Comments of

Proposed National Emission Standards for Hazardous Air Pollutants; and, in the Alternative, Proposed Standards of Performance for New and Existing Stationary Sources: Electric Utility Steam Generating Units; Proposed Rule

Docket No. OAR-2002-0056

June 28, 2004

Figure 1

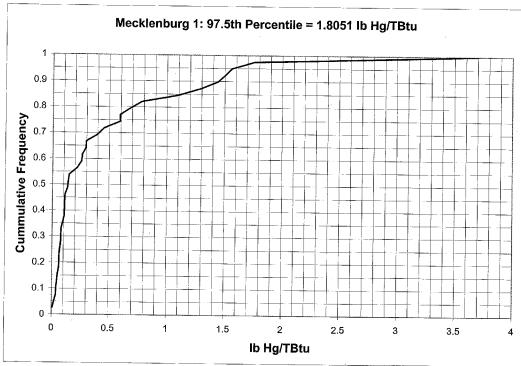
EPA's erroneous method, which came from industry consultants who developed and promoted it,⁷ is illustrated here for the bituminous subcategory but is similar for all five subcategories. Figures 1-4 show the four cumulative frequency distributions for the best-performing bituminous sources, as copied from the EPA docket.⁸ These four independent probabilistic distributions, provided by EPA, provide the starting-point for EPA's incorrect calculations and also for our own correct approach. What EPA needs to do is *combine these four distributions into a single distribution* that represents the behavior of the average. This is what the law requires. EPA could then set its emissions limit at an appropriate percentile on this combined distribution.

Figure 16

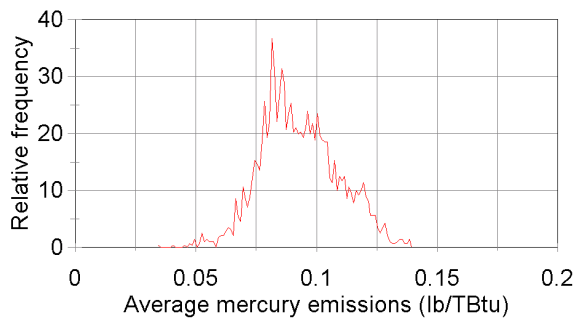
Figures 16 and 17 show the PDF and the actual test data, respectively, for the best-performing coal-refuse plants. Figure 16 shows the PDF obtained from EPA's variability analysis, as described above. Its mean and median are both about 0.09 lb/TBtu. The curve in Figure 17 shows the normal distribution that approximately represents the emission testing at the best-performing coal-refuse plants.²² The black bar along the x-axis of Figure 17 shows the range of

Figure 17

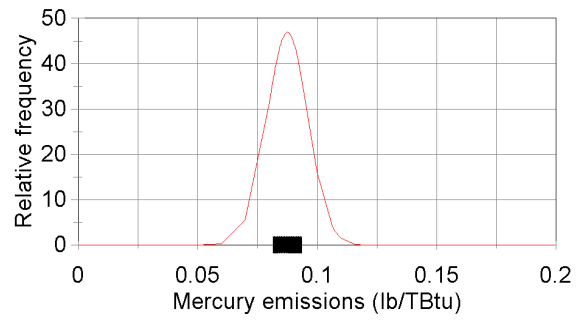
actual measured emissions (the two measured values were 0.0816 and 0.0936 lb/TBtu) from which EPA calculated a mean of 0.088 and a standard deviation of 0.0085 lb/TBtu.²³ Comparison of Figures 16 and 17 shows that these two graphs are generally similar to each other. The mean in Figure 16 is similar to the mean in Figure 17, as would be expected, since both graphs represent the average mercury emissions from the best-performing coal-refuse plants.

Figure 18

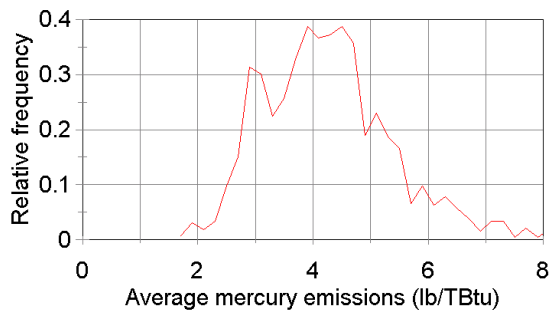
Figures 18 and 19 show the PDF and the actual test data, respectively, for the best-performing IGCC plants. Figure 18 shows the PDF obtained from EPA's variability analysis, as described above. Its mean and median are both about 4.2 lb/TBtu. The curve in Figure 19 shows the normal distribution that approximately represents the emission testing at the best-performing IGCC plants.²⁴ The black bar along the x-axis of Figure 19 shows the range of actual measured emissions (the two measured values were 5.3343 and 5.4713 lb/TBtu) from which EPA calculated a mean of 5.403 and a standard deviation of 0.097 lb/TBtu.²⁵ Comparison of Figures 18 and 19 shows that these two graphs are somewhat similar to each other. The curve in Figure 18 overlaps the mean and test data in Figure 19, as it should. The means are not as well-aligned as in the lignite and coal-refuse subcategories, but not so poorly aligned as in the bituminous and subbituminous subcategories.
